Westinghouse Electric Company
Nuclear Services
P.O. Box 355
Pittsburgh, Pennsylvania 15230-0355
USA

Your ref:
Our ref: LTR-NRC-02-60

Subject: Response to RAI on the "Topical Report on Modular Accident Analysis Program Version 5 (MAAP5) Pressurized Water Reactor (PWR) Large Dry Containment Model," WCAP-15844

Figure 1: Comparison of the MAAP5 calculated free and forced convection heat transfer and the experimental data reported by Kuhn et al.

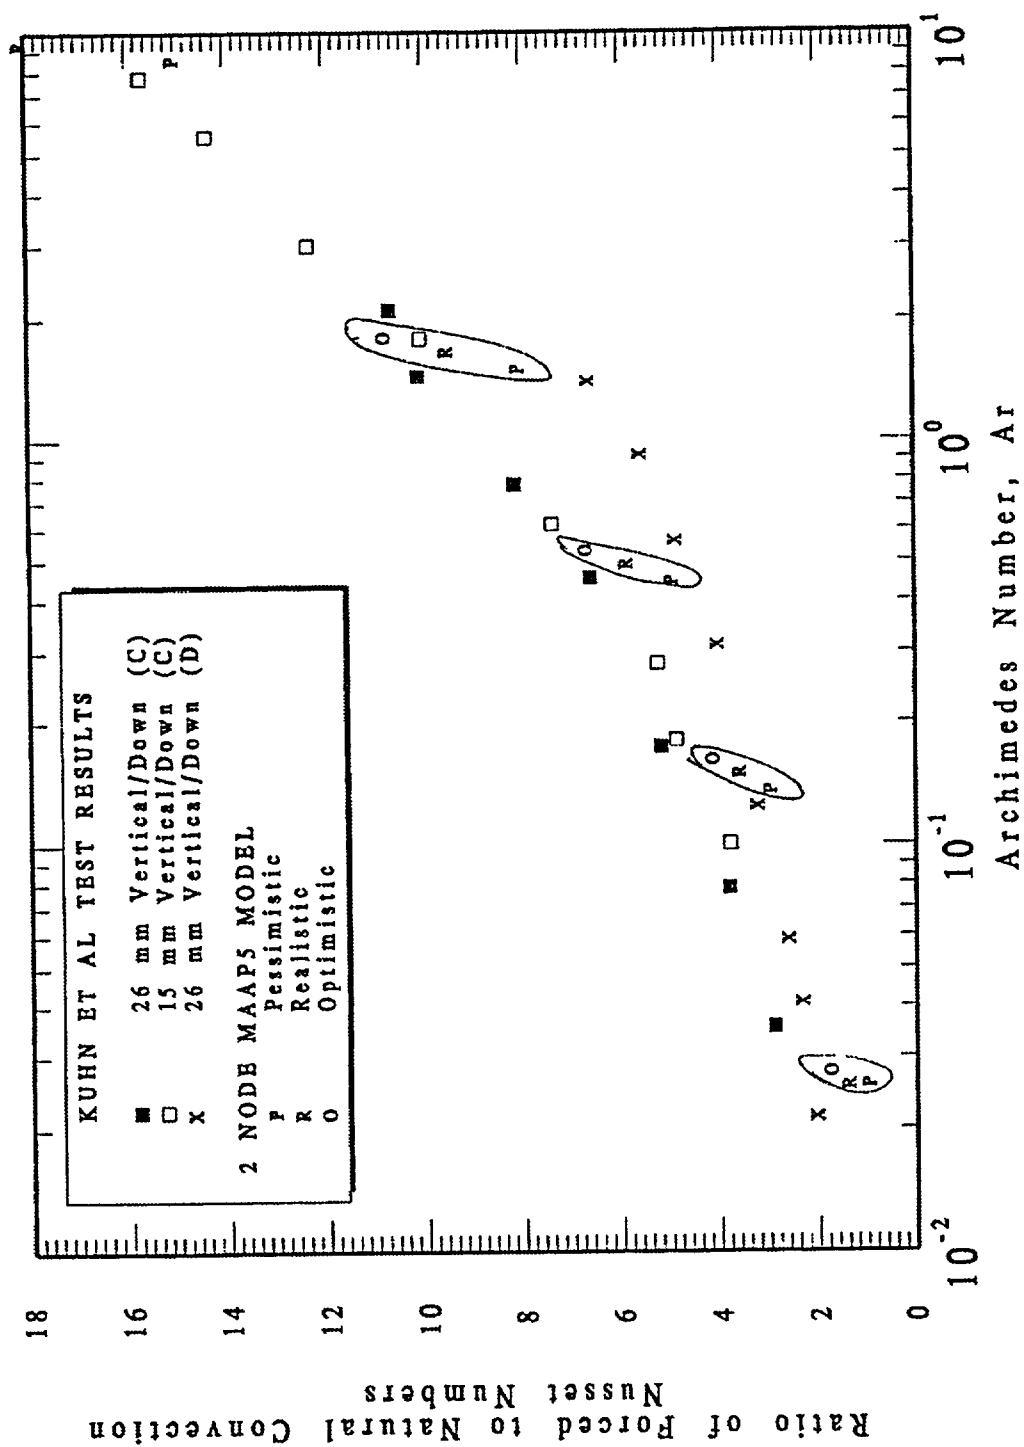
Item 2.2.5. What is the justification for using the Dittus-Boelter or any other one-dimensional heat transfer correlation with the \square momentum-driven velocity \square derived as having a property value with no directional dependence? Same question for entrainment correlations?

As additional justification for considering the "momentum-driven velocity" as a characterization of the free stream velocity to be used in correlations describing the rates of heat, mass and momentum transfer, a benchmark has been performed with enclosure experiments reported by Kuhn et al. (Kuhn, S. Z., Kang, H. K. and Peterson, P. F., 2002, "Study of Mixing and Augmentation of Natural Convection Heat Transfer by A Forced Jet in a Large Enclosure," Trans. of the ASME, Journal of Heat Transfer, Vol. 124, pp. 660-666). In these experiments, a gas jet was injected into an enclosure and an equal mass flow rate was exhausted through another port. The influence of the induced flow by the jet was characterized in terms of a ratio of the enhanced convective Nusselt number divided by the natural convection Nusselt number as a function of the Archimedes number (defined as the jet Reynolds number squared divided by the Grashof number based upon the enclosure diameter). Of particular interest in the MAAP benchmark, are the tests in which the air jet was injected vertically downward into the center of the enclosure or next to the enclosure wall. The jet flow induced a significant momentum-driven velocity as reflected by the augmented heat transfer from the heated bottom surface. (The continuity velocity in these experiments is of the order 1.0 mm/sec which is far less than the velocities required to explain the enhanced heat transfer.) Figure 1 compares the optimistic, realistic and pessimistic values for the enhanced heat transfer calculated by the MAAP5 model. It is to be remembered that the pessimistic value (that designated by the P in the attached figure) is the value that is used in evaluating the containment peak pressure and temperature response.

As illustrated, there is agreement between the enhanced forced convection heat transfer coefficients in these enclosure tests and those calculated by the MAAP model.

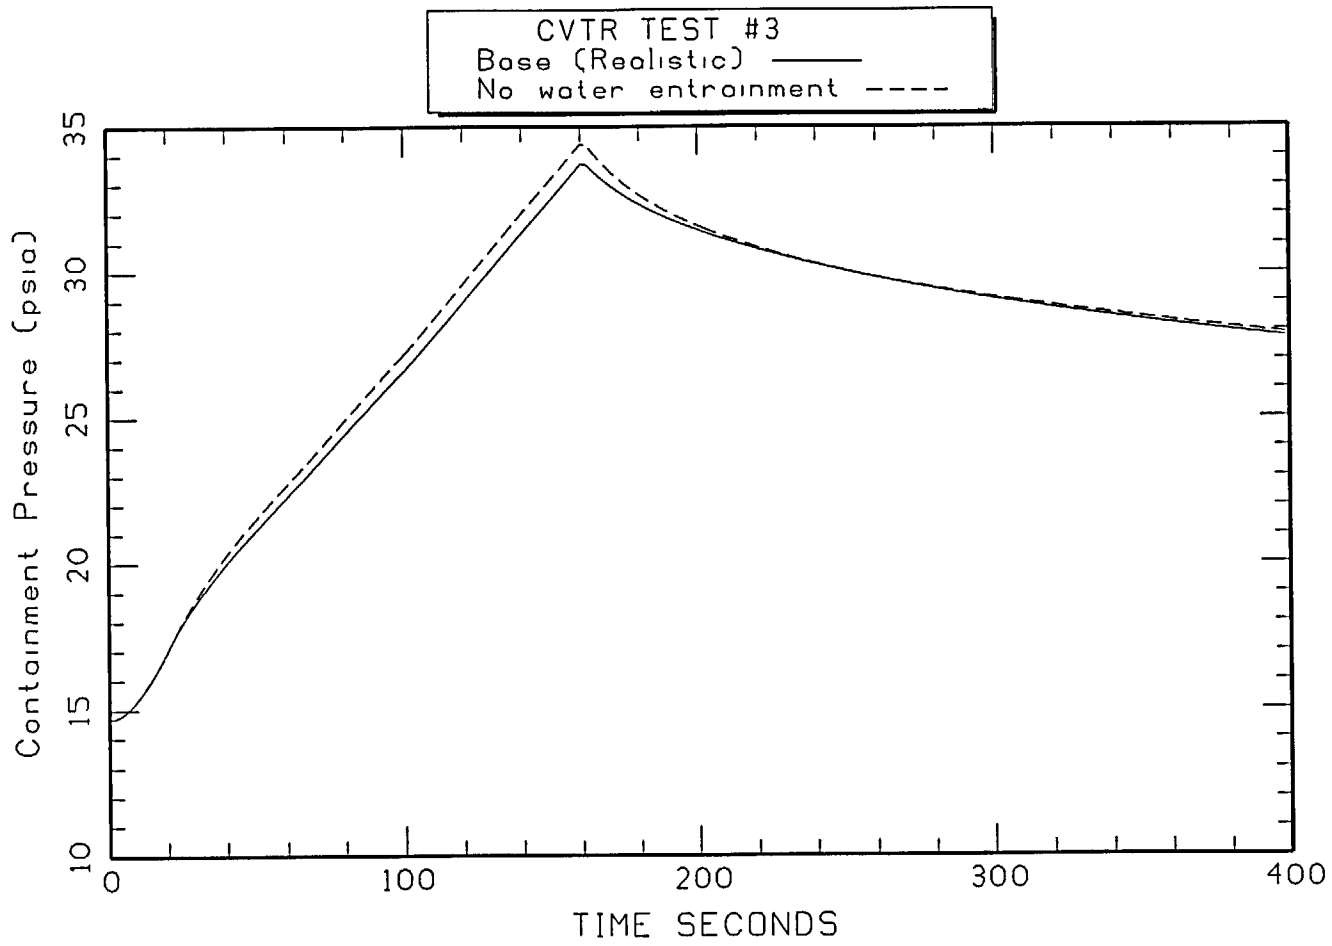
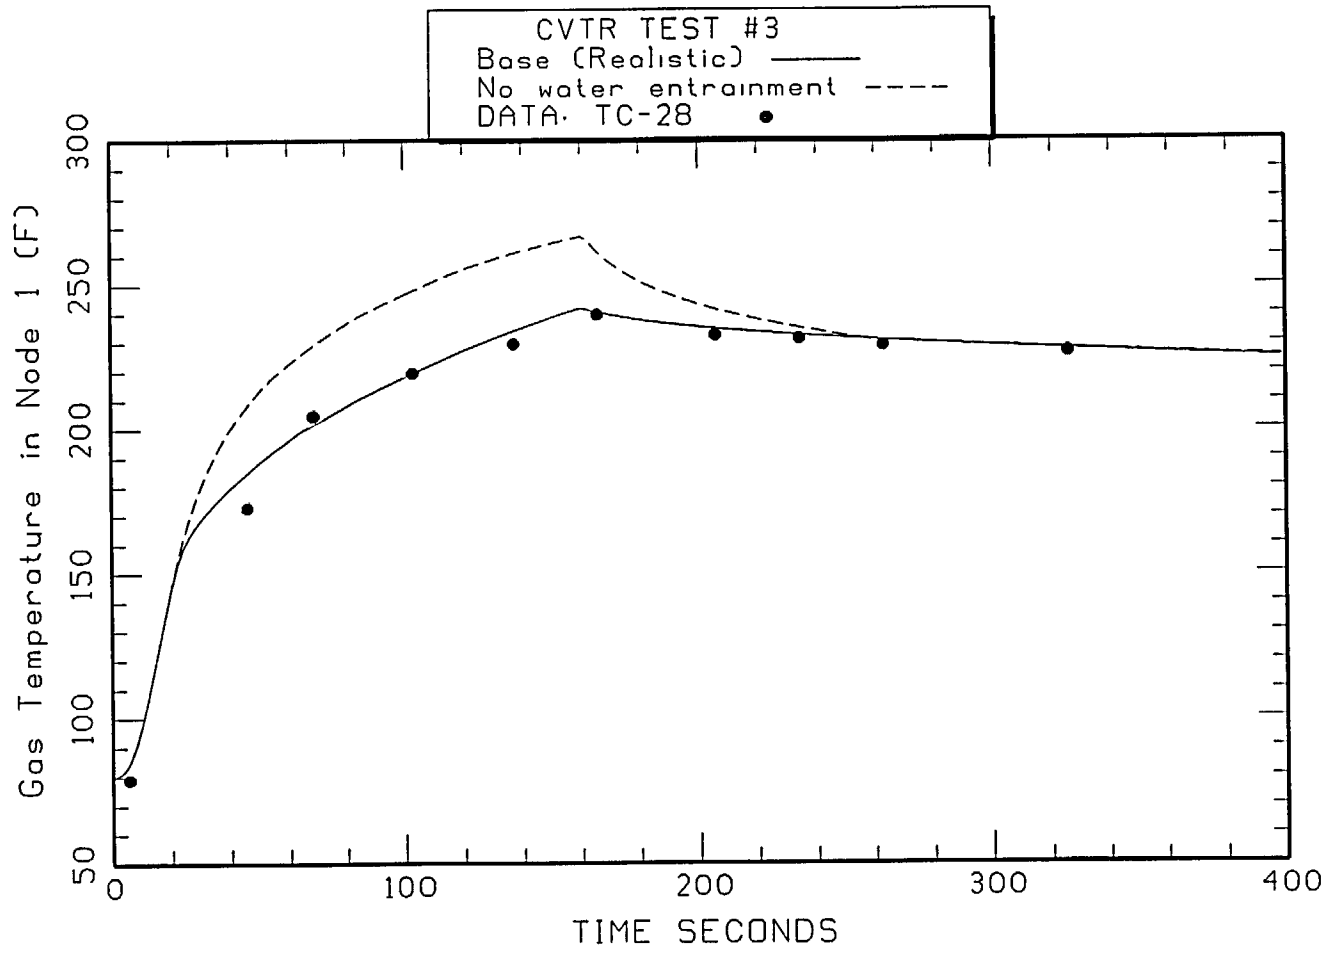
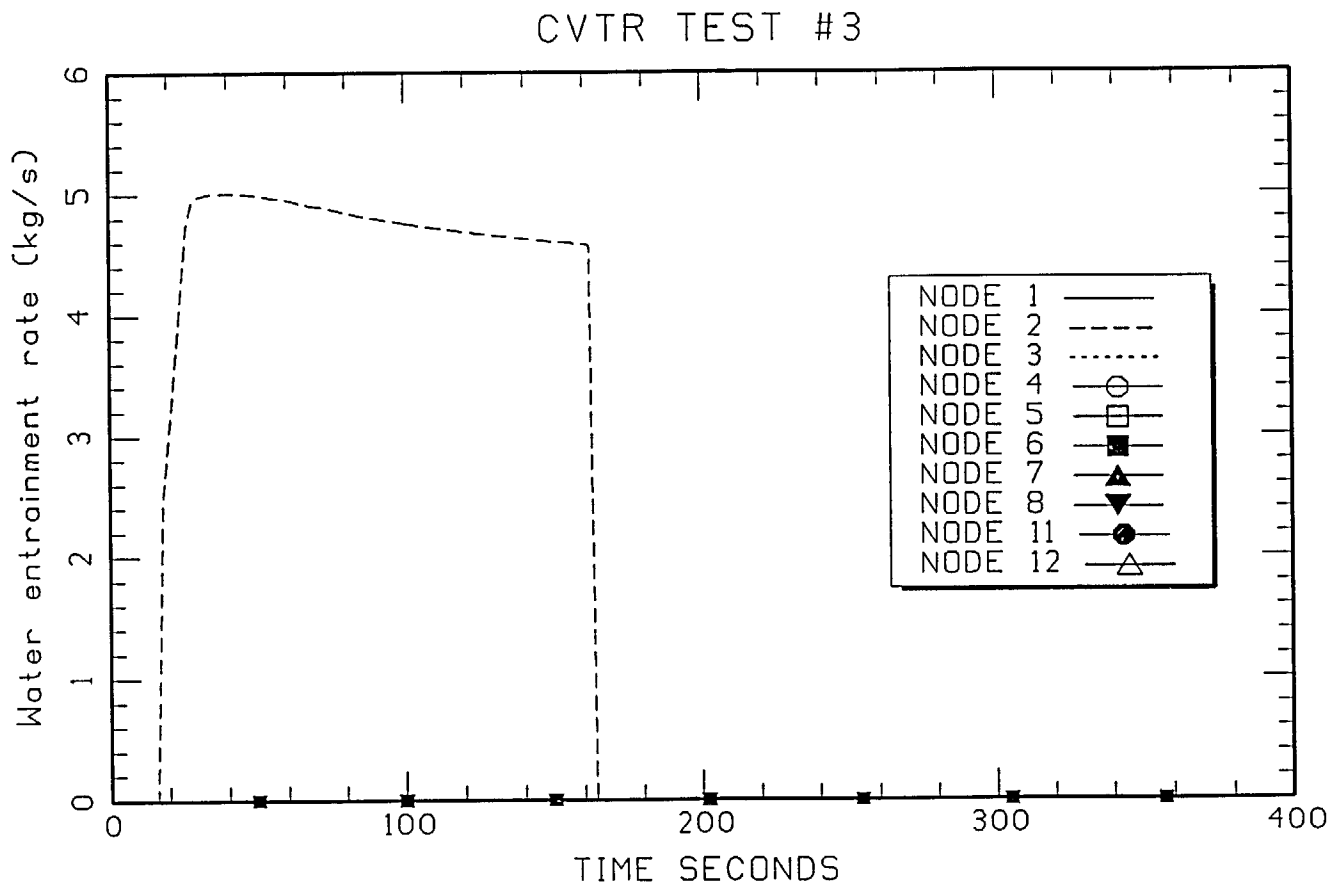
**Item 2.2.8. To what degree does water entrainment enter into the CVTR calculation?
Provide a water entrainment time history profile in compartments for test 3.**

The impact on the containment pressure and gas temperatures of water entrainment are shown in the attached plots for the CVTR test #3. The peak pressure (Figure 1) increases about 0.7 psi when water entrainment is not credited. The peak gas temperature in the node 1 (Figure 2) increases about 25°F without the water entrainment. Figure 3 illustrates that entrainment is occurring only in node #2 which is receiving all of the break discharge in this calculation.
